STAFF RECOMMENDATION 1429 Greenwood Avenue September 21, 2016

Application: New construction—outbuilding/detached accessory dwelling unit; Setback determination

District: Eastwood Neighborhood Conservation Zoning Overlay

SITE PLAN

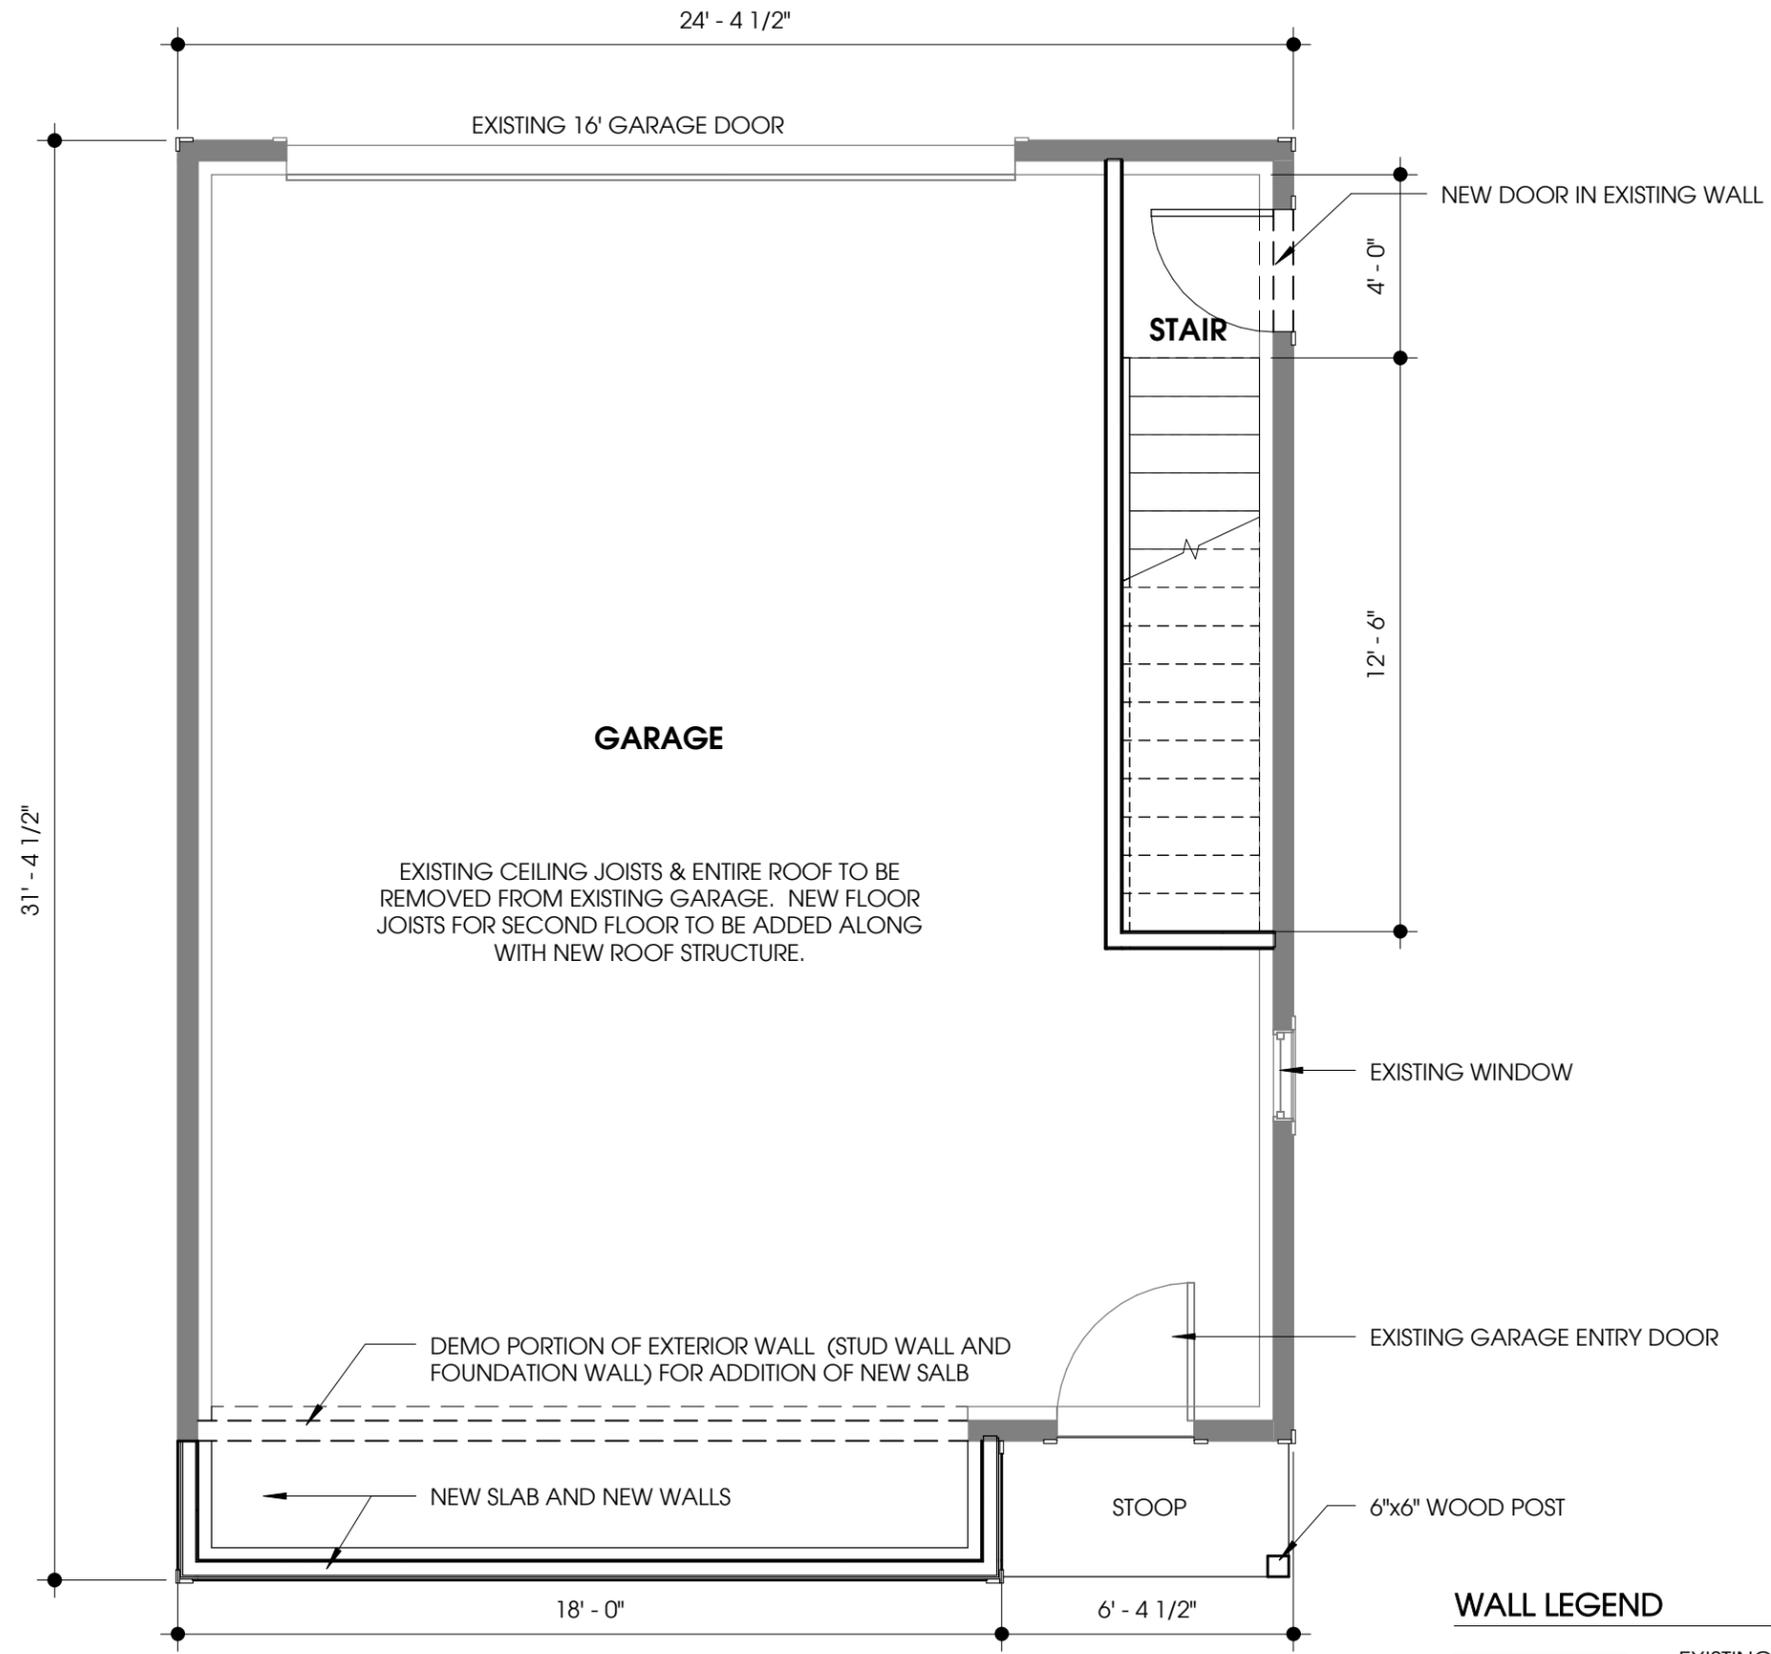
Setbacks: Even though the footprint of the converted DADU is not extending closer to any property line, the rear setback for a DADU will not be met. The footprint of the existing outbuilding is six hundred and ninety-five square feet (695 sq. ft.). The plans propose to add an additional seventy square feet (70 sq. ft.) for a total of seven hundred and sixty-five square feet (765 sq. ft.). (The lot is greater than 10,000 square feet which would allow for a maximum footprint of 1000 square feet.) When an outbuilding has a footprint greater than seven hundred square feet (700 sq. ft.), bulk zoning requires that the structure be located twenty feet (20’) from the rear property line and five feet (5’) from the side property lines.

In this instance, the structure is located at least five feet (5’) from the left side property line and ten feet (10’) from the right side property line which abuts Chapel Avenue, but it is located ten feet (10’) from the rear property line. Staff finds that the proposed rear setback is appropriate because a ten foot (10’) setback is the standard rear setback for structures that are seven hundred square feet (700 sq. ft.) or less. Also, historically, outbuildings were located at the rear of the property, close to the rear property line. A ten foot (10’) rear setback is more historically appropriate than a twenty foot (20’) rear setback and, in this case, is appropriate since the existing footprint of the structure is not proposed to be any closer to the alley. Staff recommends approval of the setback determination.

MINIMUM	PROPOSED
Space between principal building and DADU/Garage	20'	60'
Rear setback	20'	10'
L side setback**	5'	5'

R side setback**	10'	23'
How is the building accessed?	From the alley or existing curb cut	Alley
